RANCHO MURIETA COMMUNITY SERVICES DISTRICT
Sacramento County, California

Bidding and Contract Documents
GRANLEES RAW WATER INTAKE IMPROVEMENTS PROJECT

ADDENDUM NO. 1
Issued March 18, 2024

RANCHO MURIETA COMMUNITY SERVICES
 GRANLEES RAW WATER INTAKE IMPROVEMENTS
UPPER DEMOLITION PLAN

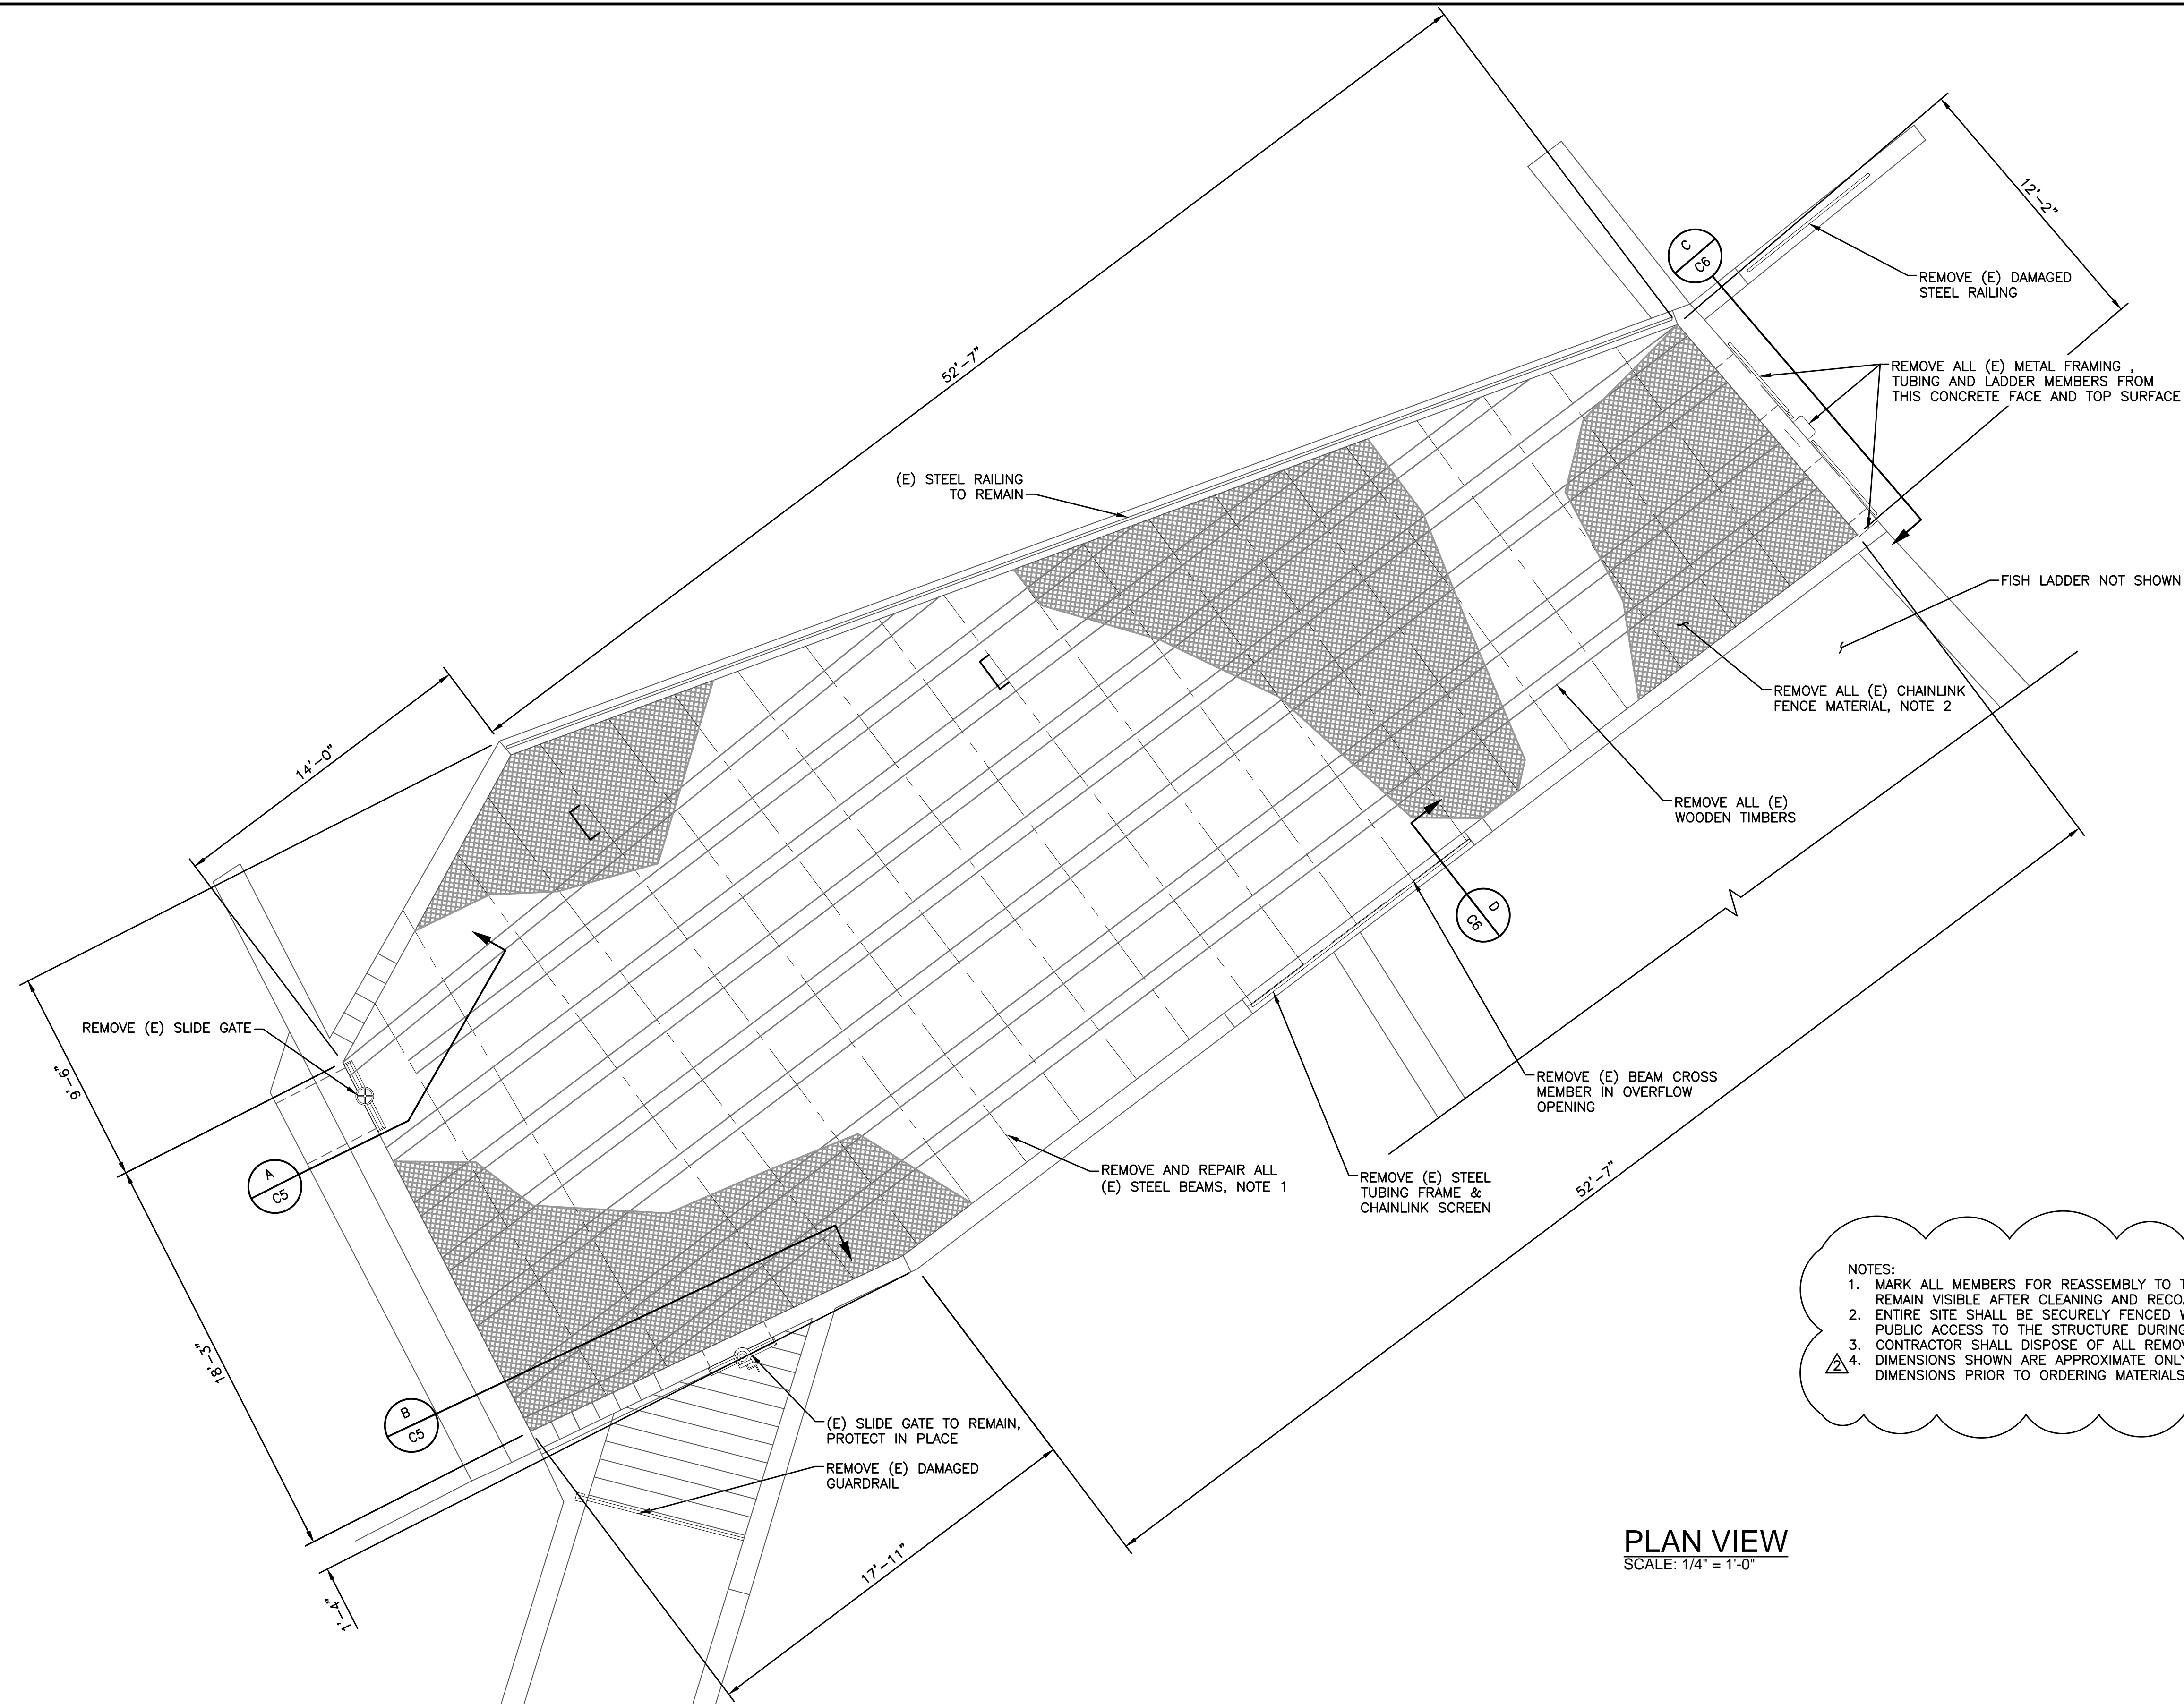
3. Please provide a specification for the access hatches and galvanized steel grating.
 - a. See Section 08 31 00 and Section 05 00 00.
4. Please provide dimensions of the structure.

- a. See the attached replacement drawing C1.
 - b. The drawing scale for drawings C1, C2, C3 & C4 is $\frac{1}{4}'' = 1'-0''$.
 - c. Dimensions provided are. The contractor shall make their own measurements for fabrication.

Typical Beam Attachment

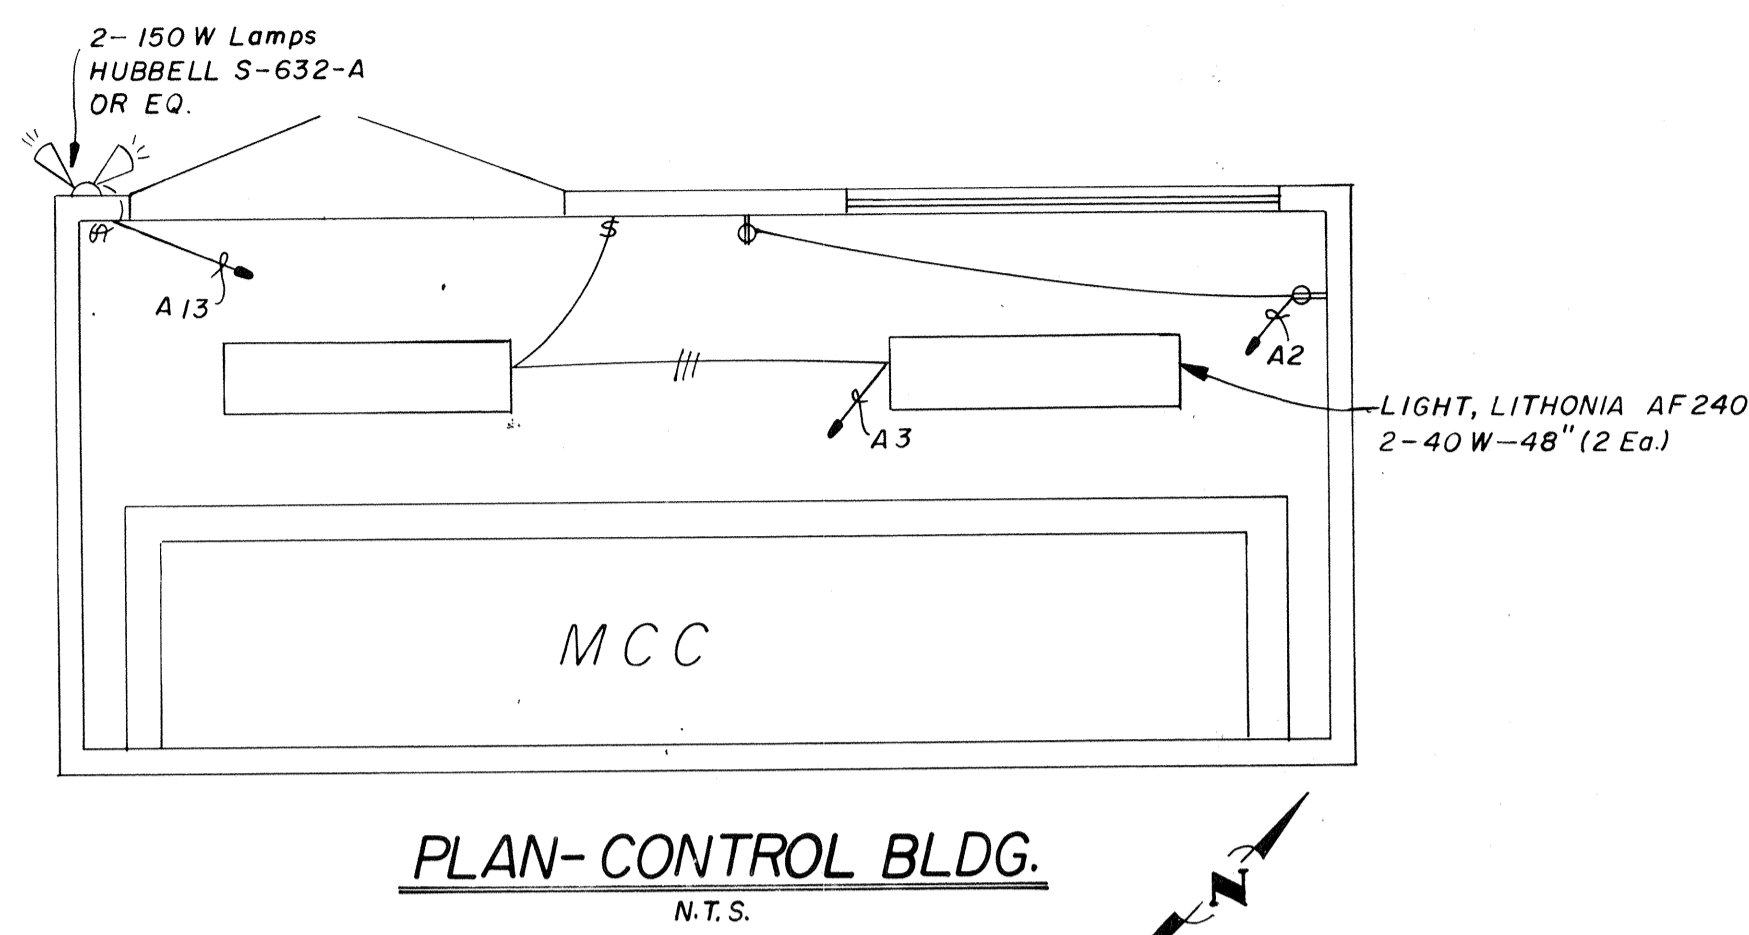
2. How are the steel beams connected to the walls?
 - a. The beams are connected via welded tees. The tees are bolted to both the walls and the beams. See the photo attached.
